Interactive comment on “WHAT-IF: an open-source decision support tool for water infrastructure investment planning within the Water-Energy-Food-Climate Nexus” by R. Payet-Burin et al.

R. Payet-Burin et al.

Received and published: 12 August 2019

Fig. 1.

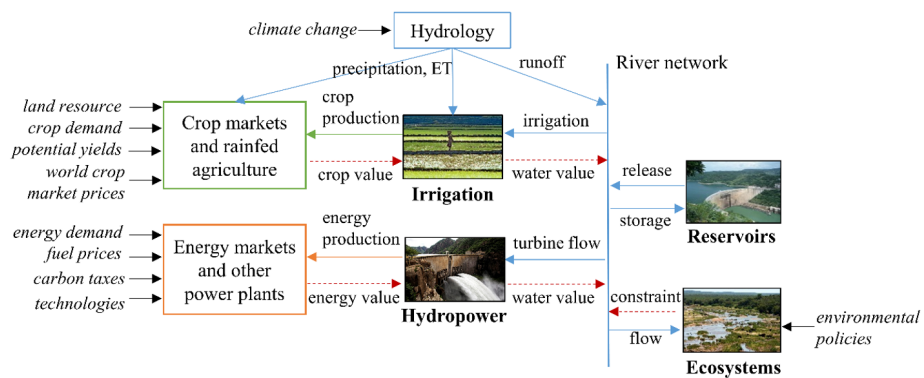
****REVIEWER COMMENT 4**** My main concern is the following; while there is a section discussing different scenarios I am missing some discussions on the sensitivity of each module to one of the other.

AUTHOR REPLY We understand this comment to be similar to comment 4) of reviewer 2, in the sense that the links between the different modules are not clear enough.

ACTION TAKEN To this purpose we added a figure showing the feedback loops among the modules, as suggested by reviewer 2 (page 17, line 9): "The main link in the nexus,

is the water resource for which hydropower, irrigation and ecosystems compete (Figure 2). The energy markets provide a dynamic value to hydropower production, while the crop markets provide a dynamic value of irrigation. The markets are therefore indirectly linked through the water trade-offs between hydropower and irrigation. Exogenous drivers on these markets such as new policies, technological and socio-economic changes, indirectly affect the water trade-offs and therefore all markets."
